# **39 Primrose Gardens – 2016/3192/P**

Delegated Report (Members Briefing)		Analysis sheet		Expiry Date:	03/08/2016		
		N/A / attached		Consultation Expiry Date:	02/08/2016		
Officer			Application N	umber(s)			
Hugh Miller			2016/3192/P				
Application A	Address		Drawing Num	bers			
39 Primrose Ga London NW3 4UL	rdens		See draft decision	n notice			
PO 3/4	Area Team Signati	ure C&UD	Authorised O	fficer Signature			
Proposal(s)							
storey extensior windows; stairca	n 5 self-contained flats to n at rear lower ground floc ase access from upper gro ssociated balustrades.	r level and rear bay	window at upper gro	ound floor level; new	timber framed sash		
Recommend	lation(s): Grant pla	anning permissi	on

**Full Planning Permission**

Rear view of 39 & adjoining properties.

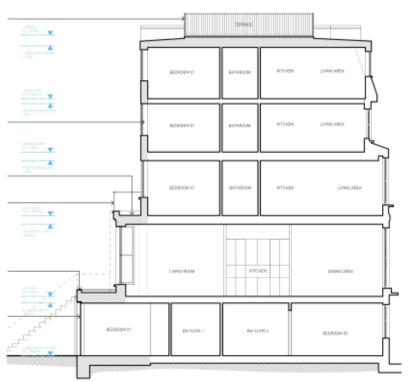
<ul> <li>Concern about loss of privacy from 1<sup>st</sup> floor roof terrace;</li> <li>Concerned about the building works itself and specifically the amount</li> </ul>							
	<ul> <li>Concerned about the building works itself and specifically the amount of dust and the impact on residents' health.</li> <li>Suggest a condition to prevent use of flat roof of rear extension as roof terrace.</li> </ul>							
	We also object to the scaffolding which is of monstrous proportions and which block the views from our property.

Concern that staircase will cause loss of privacy (relevant party wall should be raised to compensate);

The windows of the adjoining terraced houses (37 and 41 Primrose Gardens) are orientated due south-west. The size and proportions of the proposed extension, 3m deep and 3m high, is typical of many such extensions and would not seriously harm occupiers' amenity in terms of loss sun/daylight or outlook to an extent that amounts to significant demonstrable harm; therefore the proposed extension is considered acceptable.

The proposed 1st floor terrace is 'canted' and measures 1m in depth and, owing to the acute angle of view and shallow depth, would not cause loss of privacy to the occupiers' habitable room.

There is a perception of harm with regards to privacy, noise and disturbance from the proposal. The French glazed doors are orientated due west away from the neighbouring windows. The new access path at upper-ground floor level and staircase at lower ground would provide views into the rear garden and limited views into habitable rooms at nos. 37 & 41 due to the acute

angle of view and would be similar to views from the rear garden. To mitigate against harm to amenity, a condition is added to prevent the flat roof areas at upper-ground floor level on either side of the access path to be used as a roof terrace.
